Access Compliance Report

Public Rights-of-Way

(Curb Ramps)

Intersection ID: 11931	Main Street: E_17TH_ST	Cross Street: HARRILL_ST	Location: W
ADA ID: BEF4FE45F38D	Ramp Type: BlendTrans1	Initial Pass/Fail: Fail	Overall Compliance: No
		Severity Score: 35

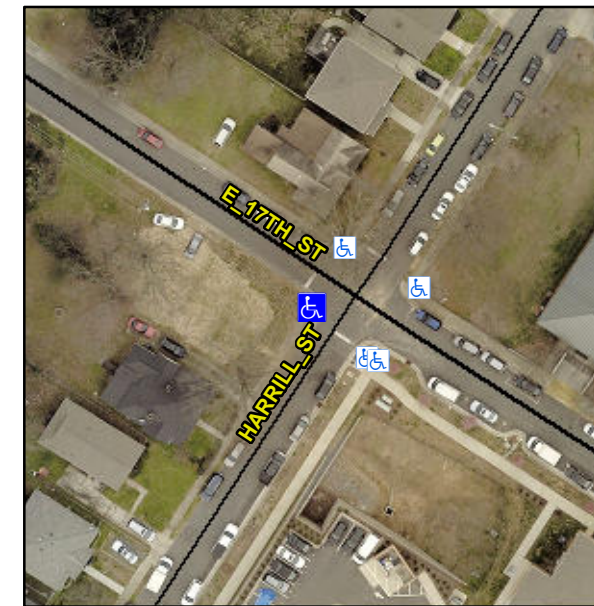
Not Found, R304.5.1

Compliance	Description	Data	Compliance	Description	Data
N/A	Ramp Length (in)	91.0	Yes	BlendTrans Slope (%)	0.6
No	Ramp Width (in)	24.0	Yes	BlendTrans XSlope (%)	1.0
N/A	Flare Type LT	N/A	N/A	Flare Type RT	N/A
N/A	Flare Slope LT (%)	N/A	N/A	Flare Slope RT (%)	N/A
N/A	Flare Traversable LT?	N/A	N/A	Flare Traversable RT?	N/A
N/A	Landing Length (in)	N/A	N/A	DWS Provided?	N/A
N/A	Landing Width (in)	N/A	N/A	DWS Contrast?	N/A
N/A	Landing Slope (%)	N/A	N/A	DWS Length (in)	N/A
N/A	Landing X Slope (%)	N/A	N/A	DWS Full Width?	N/A
N/A	Landing Curb? (Y/N)	N/A	N/A	DWS Offset (in)	N/A
N/A	Shared Landing?	N/A			
N/A	Gutter Ponding?	N/A	N/A	Gutter Slope (%)	N/A
N/A	Gutter Lip Ht (in)	N/A	N/A	Gutter X Slope (%)	N/A
N/A	Painted X Walk1?	No	N/A	Painted X Walk2?	N/A
	X Walk 1 Direction	To SE		X Walk 2 Direction	N/A
	X Walk 1 Width (in)	N/A		X Walk 2 Width (in)	N/A
	X Walk 1 Slope (%)	1.7		X Walk 2 Slope (%)	N/A
	X Walk 1 X Slope (%)	0.6		X Walk 2 X Slope (%)	N/A

N/A	Ramp inside XWalk1?	N/A	N/A	Ramp inside XWalk2?	N/A
	Road Slope (%)	0.6		Clear Space?	N/A
	Road X Slope (%)	1.7	N/A	Clear Space to XWalk (in)	N/A
N/A	Any Obstructions?	N/A	N/A	Storm Grate/Utility Hazard?	N/A
	Obstruction Type			Storm Grate/Utility Type	
		N/A			N/A
			Yes	Surface Condition? (G/P)	Good
			No	Curb Slope (%)	25.4

Remove & Replace Curb Ramp With Two New Directional Ramps or Equivalent.
